VA EXPANSION GARAGE

VA Expansion Parking Garage Bidder Questions From Dawn Carroll-Amin:

VA MEDICAL CENTER
04/28/16 ADDENDUM 1

EXPAND VISITOR/PATIENT PARKING GARAGE - PHASE 1

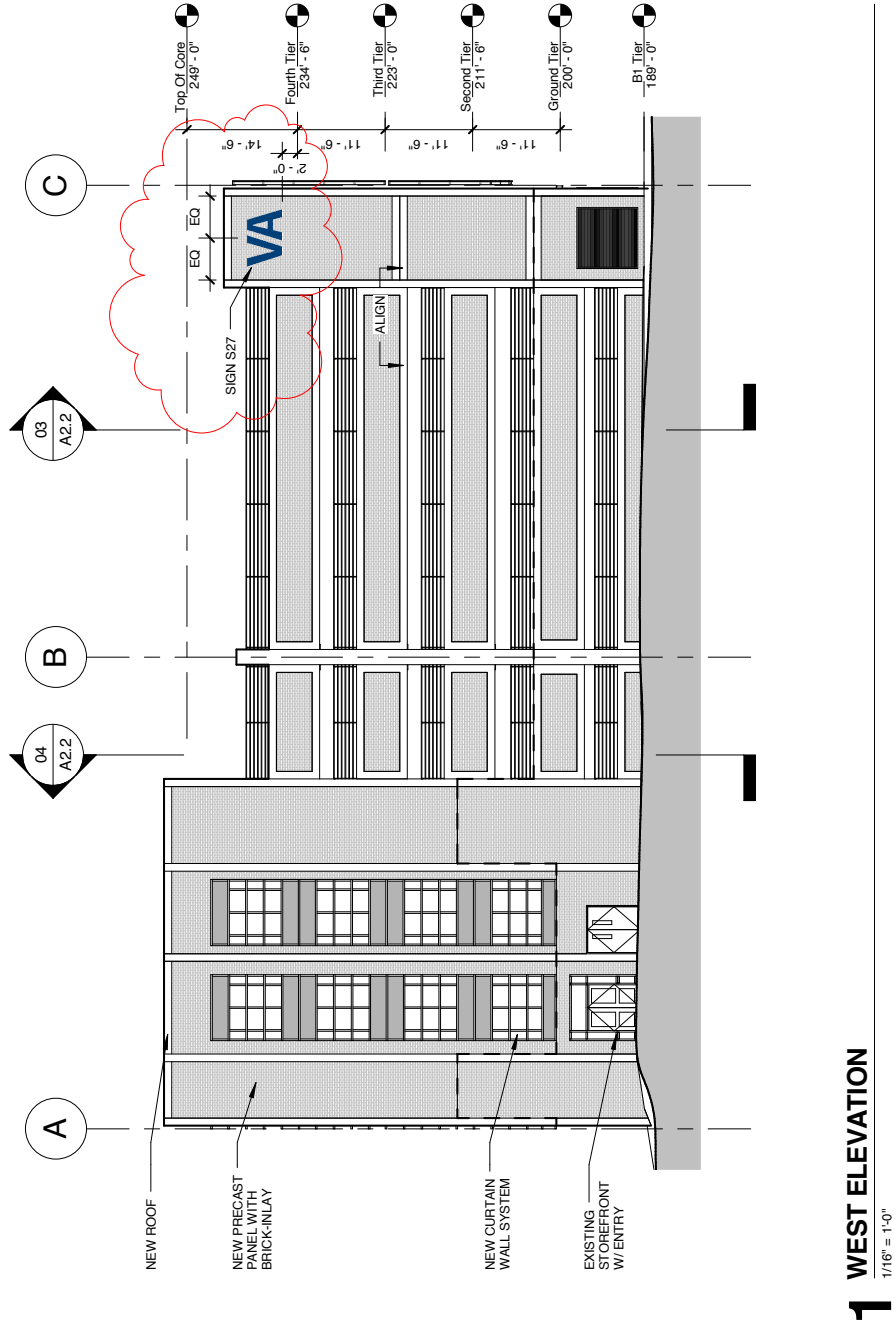
17. Blast Proof wall shown on drawing CS3.0 refers you to structural drawings for the details, which has no details. Please provide wall and foundation details.

See structural detail attached.

SK1

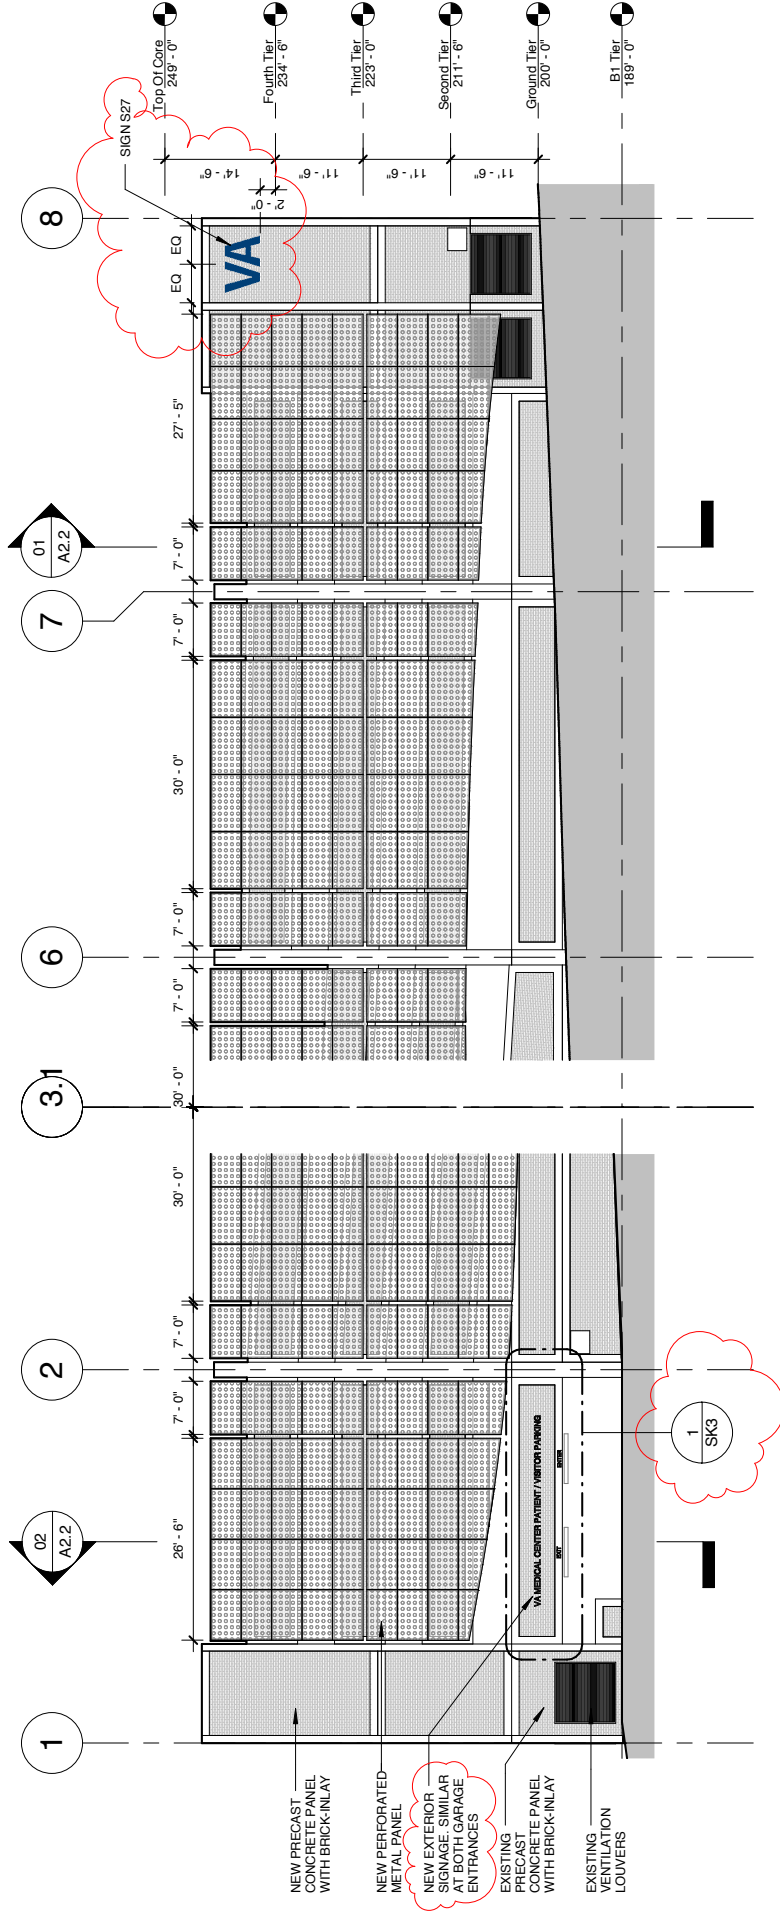
3. Sign Type S27 ("VA" dimensional letters), as shown on Sheet A6.2, is not shown on any of the exterior building elevations. However, two sets of letters (S27) are located on drawing 02/A1.6. Can you confirm this sign type is required? If so, can you provide an elevation indicating the mounting height and position of these letters. (Drawing No. A6.2 & A1.6).

Sign Type S27 is required as scheduled and indicated on the plan. See attached elevation drawing SK 1 and SK 2 for location on the building.

550 Township Line Road Suite 100 Blue Bell, PA 19422 Phone 484.342.0200 Fax 484.342.0222 www.timhaas.com
 Tim Haas, P.E. 1/10/2016
 Tim Haas, P.E. 1/10/2016

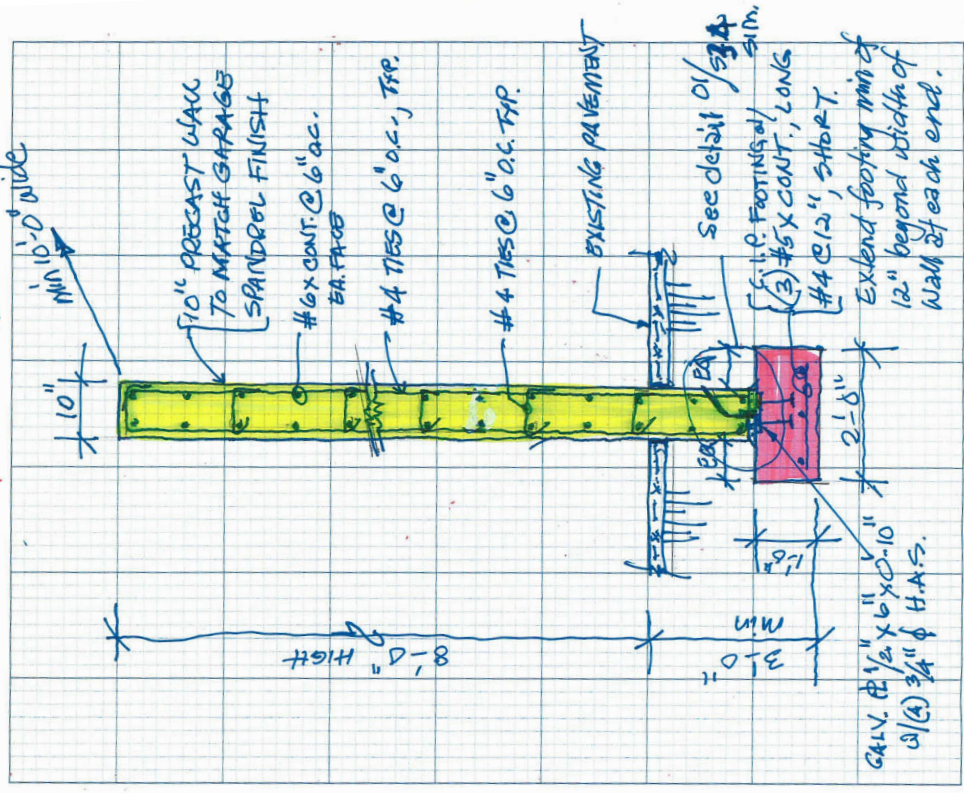
4. For the new exterior dimensional letters at the entrances/exits as shown on elevation drawing 01/A2.1 and 04/A2.1, the text reads, "VA MEDICAL CENTER PATIENT/VISITOR PARKING" (for both the East and South elevations). However, on the sign schedule on Sheet A6.2, the text reads, "ENTER" and "EXIT" for sign Type S1 and S2 respectively. Can you confirm which message is correct? (Drawing No. 01/A2.1 & 04/A2.1 & A6.2).

5. On the elevation drawing 01/A2.1 and 04/A2.1, it appears to show overhead wall mount panels, mounted centered above the in/out lanes (one for "In" with arrows and one for "Out" with do not enter symbols). However, there are no sign marks on the sign location plans (Sheet 01/A1.3 and 01/A1.4) indicating

these signs are required at these locations. Can you confirm if these overhead panels are required at the entrance/exit locations (Drawing No. 01/A2.1 & 04/A2.1).

"VA MEDICAL CENTER PATIENT/VISITOR PARKING" is not part of the parking directional sign package but is required in two locations as indicated on the elevation drawings. The materials, font, and dimensions are shown on the elevation drawings and detail. The "ENTER" and "EXIT" are scheduled signs (S1 and S2). The size of the lettering has been revised to 6" high. See the revised sign schedule SK6e attached and drawing SK 3 attached.

The elevation has been revised to say "ENTER" and "EXIT" to coordinate with the sign schedule. See SK 3 and SK 6 attached.
